UNITED STATES PATENT AND TRADEMARK OFFICE

| APPLICATION NO. | FILING DATE | FIRST NAMED INVENTOR | ATTORNEY DOCKET NO. | CONFIRMATION NO. |
|---|-------------|----------------------|---------------------|------------------|
| 10/701,698 | 11/05/2003 | Ricardo Blank | 8496-US | 7089 |

| Office Action Summary | Application No. | Applicant(s) | |

DETAILED ACTION

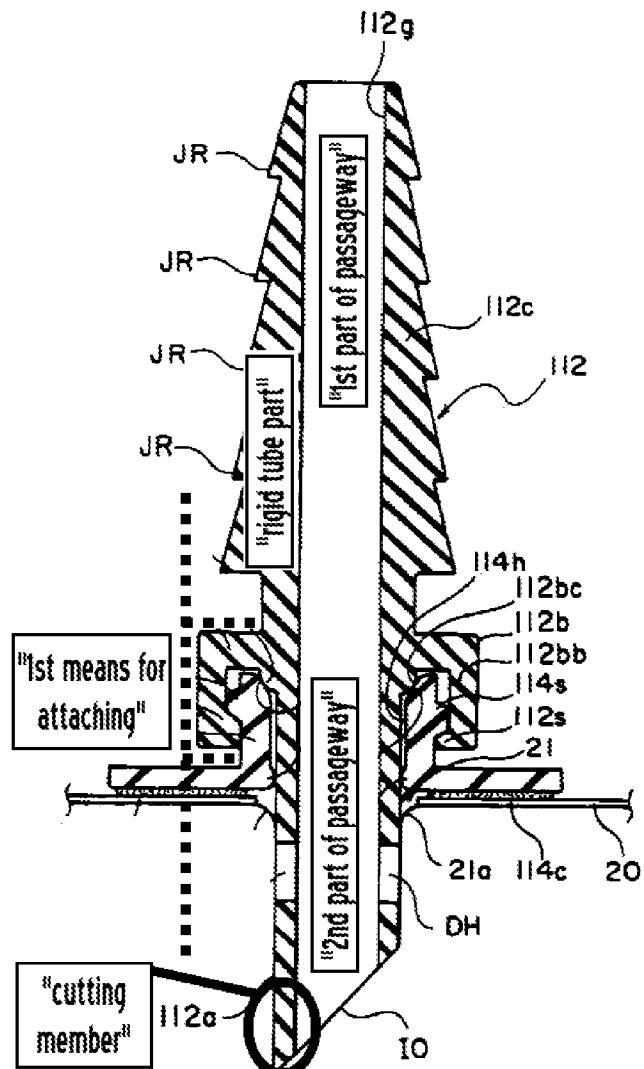
the cutting member protruding from an interior of the first means (annotated Fig. 6, pointed end 112a protrudes

downwards from within the inner perimeter of annular rim 112b).

16. Regarding claim 3, Kawaguchi discloses a cutting member protruding from the connector device in a direction towards the laminated paper packaging system for cutting the laminated paper packaging system upon screwing the connector device onto the laminated paper packaging system (¶ [0049], [0051], annotated Fig. 6, pointed end 112a).
